251 Goldhurst Terrace

Delegated Report		Analysis sheet		Expiry Date:	23/01/2024	
(Members Briefing)		N/A		Consultation Expiry Date:	24/03/2024	
Officer				Application Number		
Sarah White				2023/5057/P		
Application Address			Drawing Numbers			
251 Goldhurst Terrace London NW6 3EP				See draft decision notice		
PO 3/4 Area Te	am Signatur	e C&UD		Authorised Officer Signature		
Proposal(s)						
Replacement of hardst	anding in fore	ecourt (retrospe	ective).			
	Crowt com	aliti a mal mlano	!	sion with warning of F	'nforcement	
Recommendation:	Grant conditional planning permission with warning of Enforcement Action				morcement	
Application Type:	Househol	Householder Application				
Conditions or Reasons for Refusal:	Refer to Draft Decision Notice					
Informatives:						
Consultations						
Summary of consultation:	A site notice was displayed near to the site on 28/02/2024 (consultation end date 23/03/2024). A press notice was advertised in the local paper on 29/02/204 (consultation end date 24/03/2024).

Proposal: Replacement of hardstanding in forecourt (retrospective)

Figure 2. Proposed Site Plan

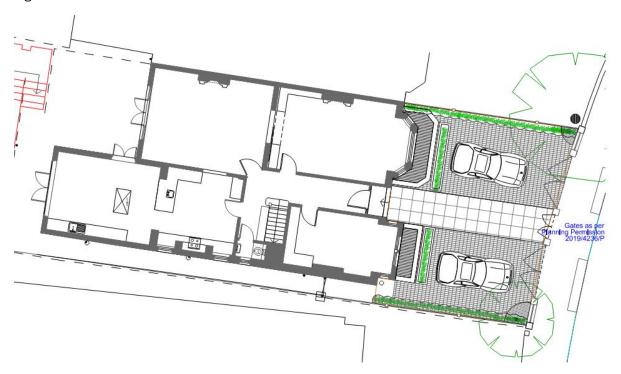
1.1. The application seeks retrospective permission for the replacement of hardstanding within the forecourt. The forecourt has been repayed with Marshall Standard concrete block paying in colour 'charcoal'. The proposed plans show boundary planting along the side boundaries in addition to a planter box in front of each of the front light wells (two in total).

- 1.2. The following revisions have been made to the proposal during the course of the application:
 - Removal of ground and side lighting
 - Insertion of a York stone path in the centre of the forecourt in the same location as the previous entrance path.
 - Insertion of permeable drainage channels on either side of the centre path

- 3.7. The design of the proposal has been amended since the original submission to include a York stone path down the centre of the two parking spots, on the line of the original, to recreate this historic delineation between paving and garden area.

Within three months of the date of this decision, the proposed York stone pathway and permeable drainage channels stall be installed and thereafter retained and maintained.

Figure 3. Pre-existing Site Plan

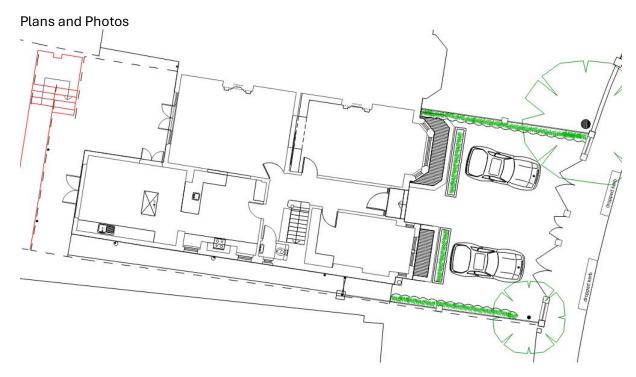
- 3.5. The pre-existing hardstanding at the application site comprised two cobbled car parking bays, either side of a central stone path, with a matching stone path on the eastern side which led to the side passage and bin storage. There were also hedges along the side boundaries and areas of planting along the front of the dwelling.
